New Turbine “V” Series Service Filters

2020V/2040V fuel filter/water separator service filters for new Racor Turbine Series FV and VMA assemblies.

Distinguishing between the filters.

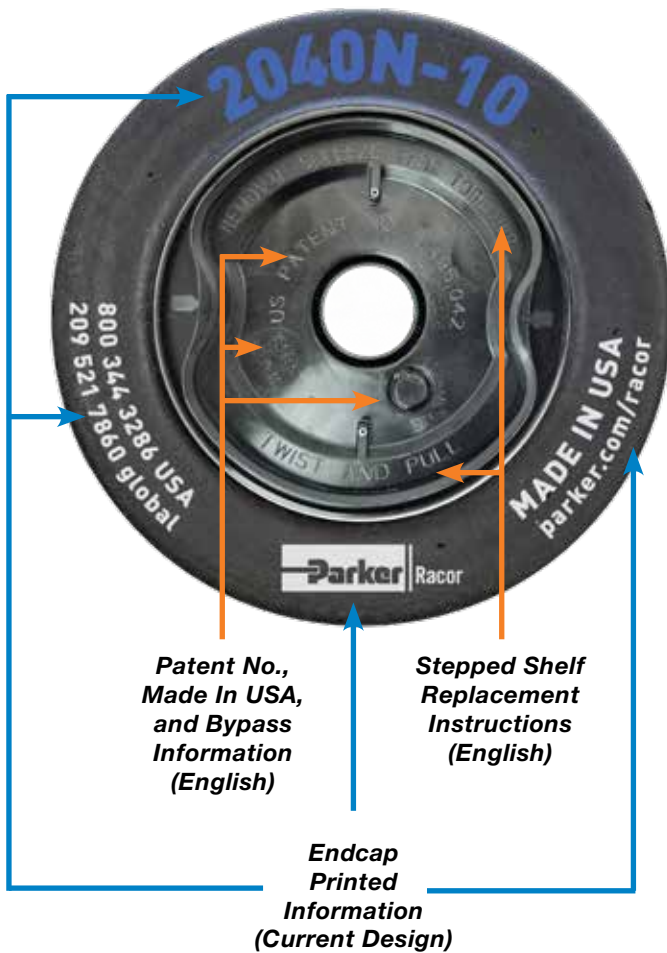
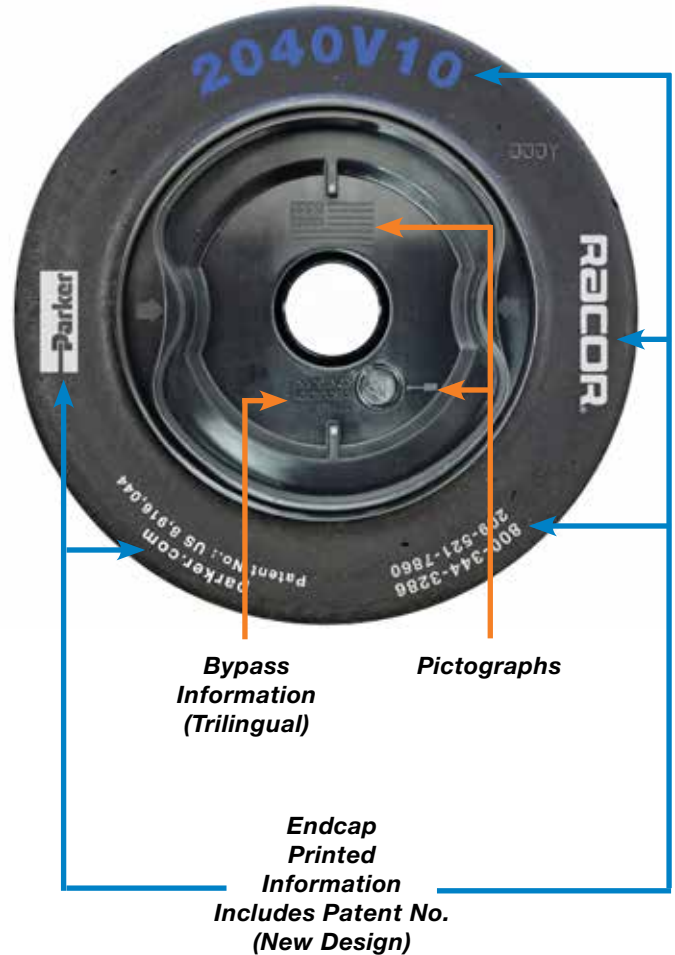
The Turbine service filters are designed for the new 900FV, 1000FV, 900VMA, and 1000VMA (marine application). The service filters are backward compatible with previous models. **Note: Old and current service filter part numbers will not work in the new FV and VMA housings. New part numbers are backward compatible with previous models.**

This is a running change.

The 2020N and 2040N filters will not work in the new FV or VMA model assemblies.

The 2020V and 2040V service filters are backward compatible for the following:

Assemblies	Models
900	FH, FG, FGM, FF, FE, MA and MAM
75900	FHX, FGX, FGM, MAX and MAXM
1000	FH, FG, FGM, FF, FE, MA and MAM
731000	FH, FG, FGM, MA and MAM
751000	FHX, FGX, FGM, MAX and MAXM
771000	FH, FG, FGM, MA and MAM
791000	FHV, FG, FGM, MAV and MAVM
